File Ref: SSD-27208140_RTS

**RE: Response to Submissions
St Aloysius College - Rozelle Campus
Property: 2A-2B Gordon Street & 48 Victoria Road, ROZELLE**

Figure 1: Shuttle Bus – gate encroachment. Source: TAIA submitted by the applicant.

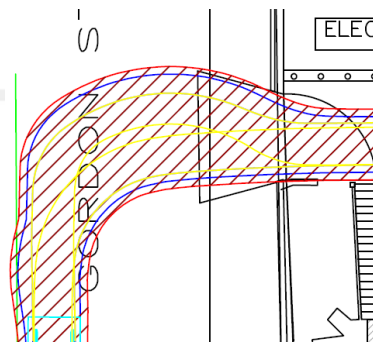
- i. As shown in Figure 1 below, the swept paths show that the manoeuvre is very tight, and the gate encroaches within the 300mm clearance bands either side of the vehicle. Further investigation should be undertaken to explore whether there is scope to widen the entry gates and driveway.

Figure 2: Swept paths - bollard and kerb: Source: TAIA submitted by the applicant.

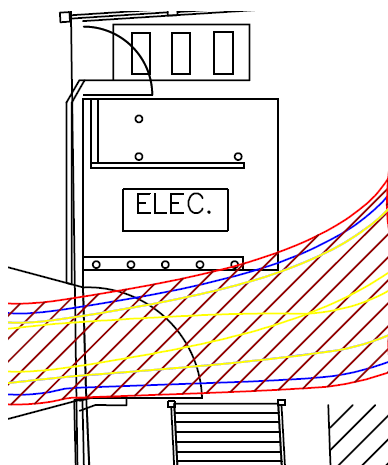
- ii. As shown in Figure 2 below, the swept path also details that the shuttle bus will impact a bollard protecting the electricity substation and drops off the edge of the kerb shown circled in red (Figure 3). Further investigation should be undertaken to explore whether there is scope to set the kerb back and to relocate the bollard to allow for better manoeuvrability of the shuttle bus.
